Item ID: D350-689-043 Accept *N9000040100* Setup Start *NS1*
 Revision ID:
 Item Name: Dual High Back Seat Assembly Stop *NS2*

DART SERVICE INSTRUCTION

TO AMEND INSTALLATION INSTRUCTIONS IIN-D350-689 REV. B
AND INSTRUCTIONS FOR CONTINUED AIRWORTHINESS ICA-D350-689 REV. 1
REF. TCCA STC: SH02-33
REF. FAA STC: SR01620NY
REF. EASA STC: EASA.IM.R.S.01453
REF. TCA STC: 2005S03-09

| DE APPR. | | INSTALLATION CHANGE | NTS |

FIGURE 1: UPDATES TO CROSS SECTIONS F-F AND M-M
 With reference to Figures 5 and 7 of IIN-D350-689
 (Figures 25-5 and 25-7 of ICA-D350-689)

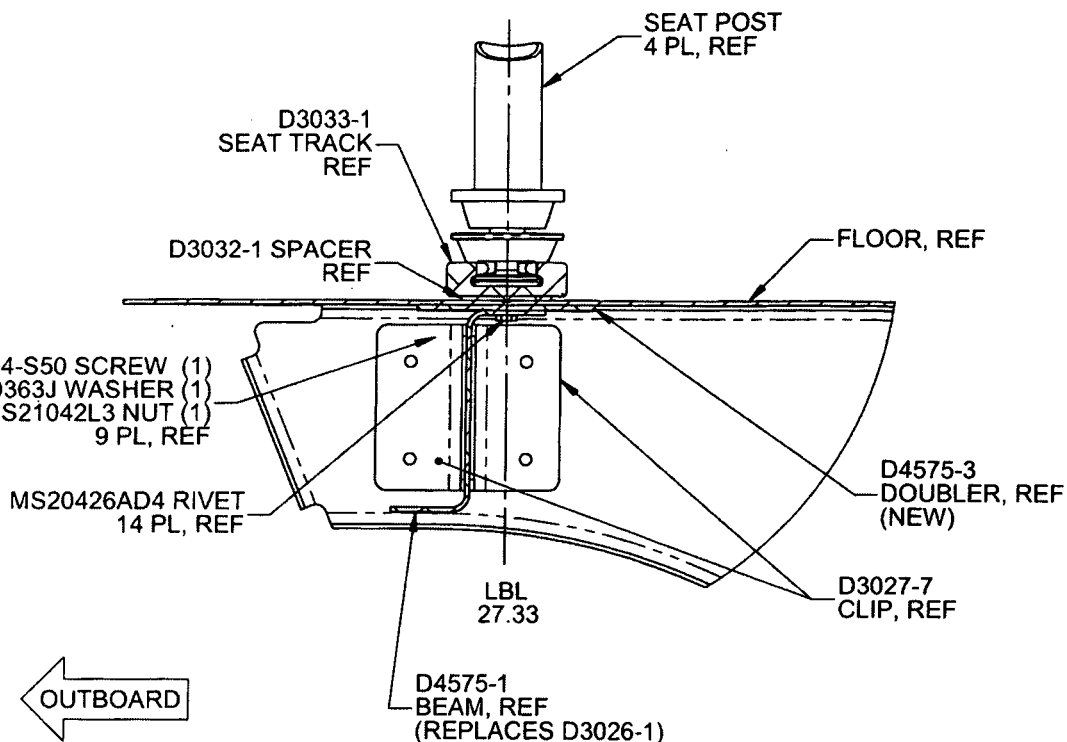
If there is an existing stringer at LBL 27.33, it will need to be removed from that location. Locate D4575-1 Beam, D4575-3 Doubler, and D3032-1 Spacer as shown in Figure 1 of this Service Instruction. Transfer drill existing holes from the aircraft floor to the D4575-1 Beam, D4575-3 Doubler, and D3032-1 Spacer. Ensure 1.0" to 1.5" rivet pitch and add additional holes if required. If there is no existing stringer, locate D4575-1 Beam, D4575-3 Doubler, and D3032-1 Spacer as shown in Figure 1 of this Service Instruction and drill Ø0.128" holes on a 1.0" to 1.5" pitch.

If there is an existing stringer at LBL 27.33, it will need to be removed from that location. Locate D4575-1 Beam and D4575-3 Doubler as shown in Figure 2 of this Service Instruction. Transfer drill existing holes from the aircraft floor to the D4575-1 Beam and D4575-3 Doubler. Ensure 1.0" to 1.5" rivet pitch and add additional holes if required. If there is no existing stringer, locate D4575-1 Beam and D4575-3 Doubler as shown in Figure 1 of this Service Instruction and drill Ø0.128" holes on a 1.0" to 1.5" pitch.

FIGURE 3: RELIEFS ON D4575-1/-3
(ONLY D4575-1/-3 SHOWN FOR CLARITY)
VIEW LOOKING INBOARD

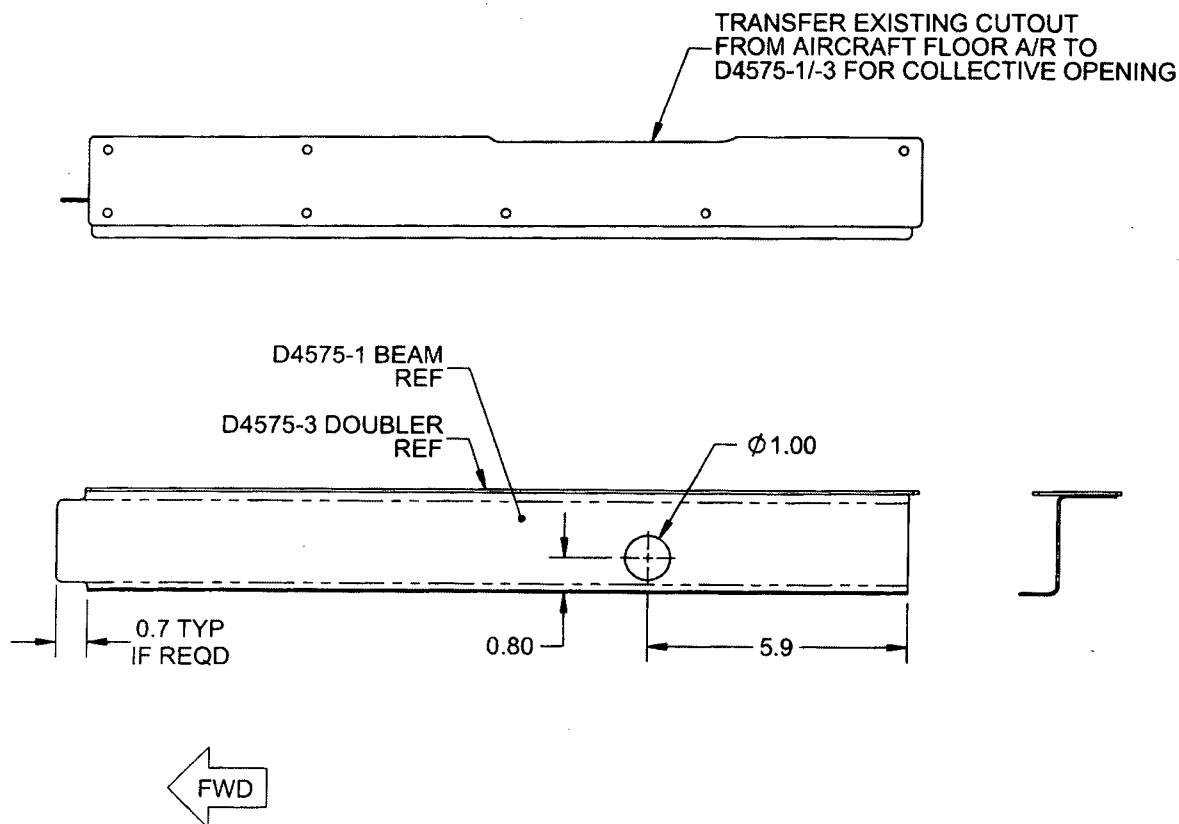
Note: Drill a Ø1.00" (Ø25.4 mm) hole in the D4575-1 Beam to clear extension tube of collective and cutout as required for clearance of collective opening and fwd bulkhead as shown in Figure 3 of this Service Instruction.

Note: Drill a Ø1.00" (Ø25.4 mm) hole in the D4575-1 Beam to clear extension tube of collective and cutout as required for clearance of collective opening and fwd bulkhead as shown in Figure 3 of this Service Instruction.
